**RE: Lomas Town Homes  
Grading and Drainage Plan  
Engineer's Stamp Date 12-21-2016 (file: K22D057)**

Project Title: LOMAS TOWNHOMES Building Permit #: \_\_\_\_\_ City Drainage #: K22-D057

DRAINAGE REPORT

**LOMAS TOWN HOMES**  
**12844 LOMAS NE**

off site basin map

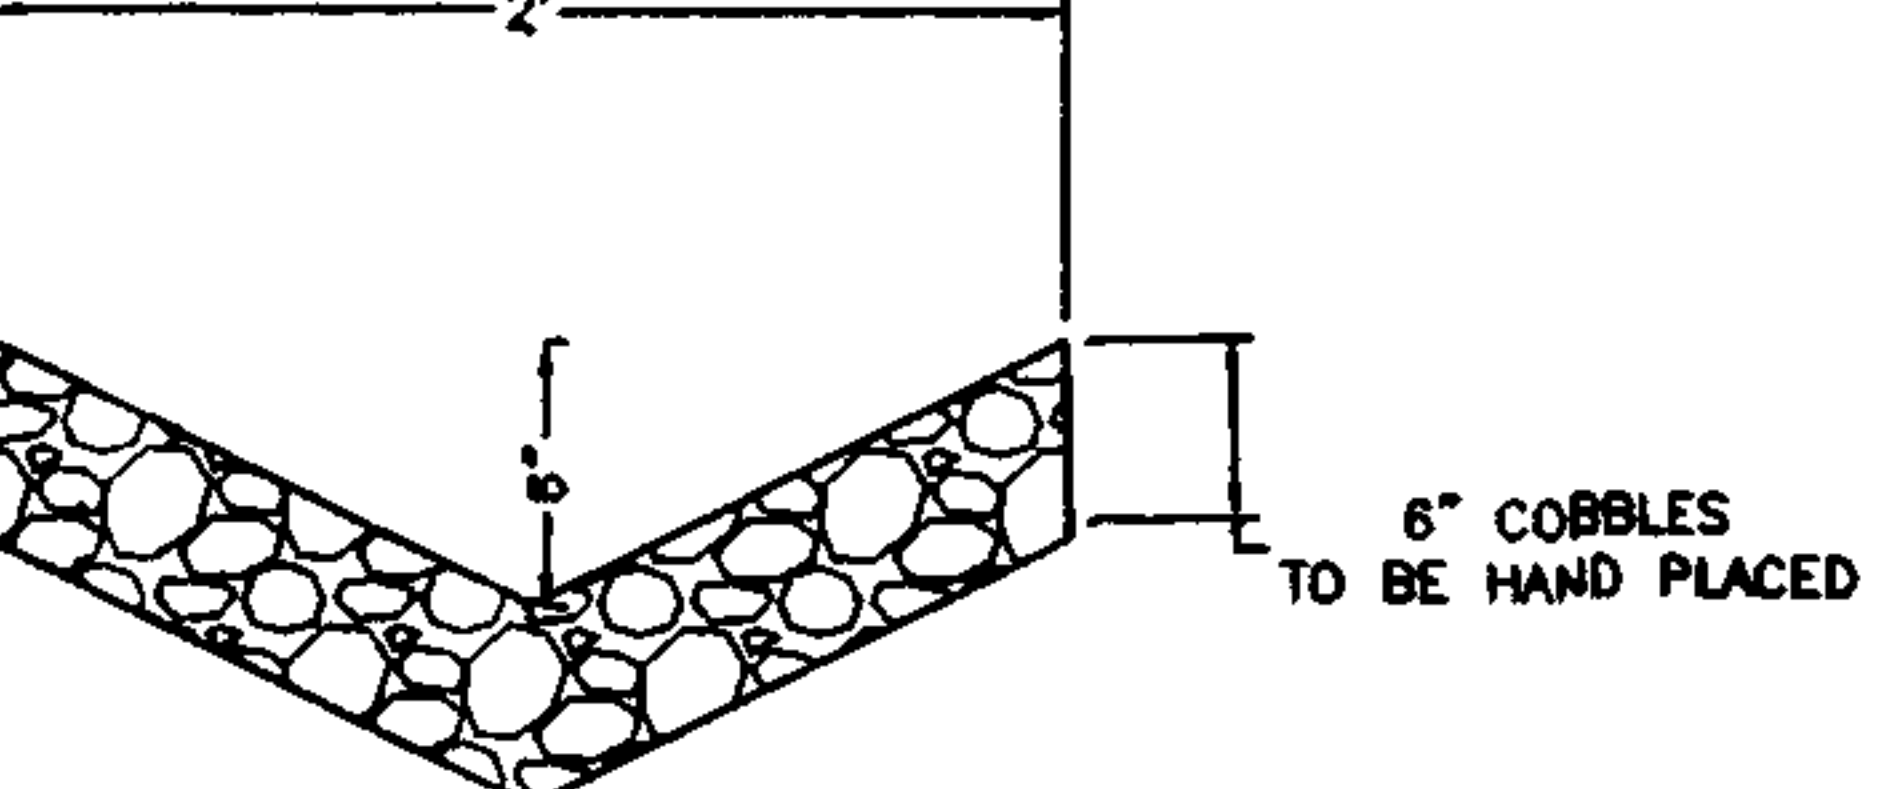
1. Provide a basin map for the offsite basin. Include calculations for flow and volume. It appears the swale in the southeast corner drains north. Shouldn't it drain south?
2. Provide the outfall location for the offsite basin.
3. The plan doesn't appear to provide storm water quality for basin C.
4. The pond in the northwest corner appears to have zero volume, pond bottom 99.5, culvert invert 99.5.
5. Provide a build note for the curb cut in the parking island in the middle of the site. It seems a curb cut on the east side of parking island would also be beneficial.
6. Please add that an excavation permit or work order is require for grading the alley.
7. Please revise the water quality cobble swale detail to agree with the build note.
